Safety Defect and Noncompliance Report Guide for Vehicles  
**PART 573 Defect and Noncompliance Responsibility and Reports<sup>1</sup>**

On FEBRUARY 10, 2011, STARTRANS [MFR] decided that a defect which relates to motor vehicle safety exists in the motor vehicles listed below, and is furnishing notification to the National Highway Traffic Safety Administration in accordance with 49 CFR Part 573 Defect and Noncompliance Responsibility and Reports.

Re: GEN V EM-1 Evaporator Fuse Assembly  
Recall #11E-003

**Subject: EM1 Gen V Evaporator Units**

Old Fuse Holder

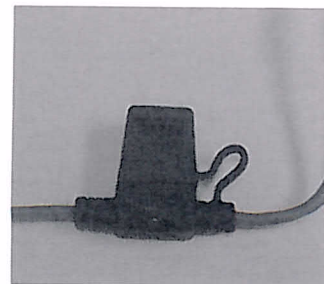
THE EM-1 FUSE HOLDER MAY WITH TIME AND TEMPERATURE AND OR VIBRATION MAY LOOSEN IN THE FUSE HOLDER CAUSING HIGH RESISTANCE.

- 2) Once the cover has been removed, the identification tag containing the unit part number, manufacture date, and serial number can be found on the motor "cradle" mount, as seen in the photo below (on left). Compare the information to the above mentioned manufacture date, and/or serial number. Units employing a fuse holder as appears circled in red below require the upgrade with the new fuse holder.

The EM1 GenV blower motor fuse assembly could fail in an unsafe manner, creating a potential fire hazard. We are advising that any units manufactured between January 1, 2006 and December 2010 must have the evaporator motor in-line fuse assembly upgraded with the retrofit kit 74-62056-00. The only units affected are EM1 GenV evaporator modules, part numbers 77-62512-XX and 77-62112-XX, with serial numbers between KNT90890232 and NNE91230058. Customers with EM1 GenV units prior to the above mentioned serial numbers and dates that have had Carrier replacement motors 54-00621-00 installed, will also require this upgrade.

New Fuse Holder
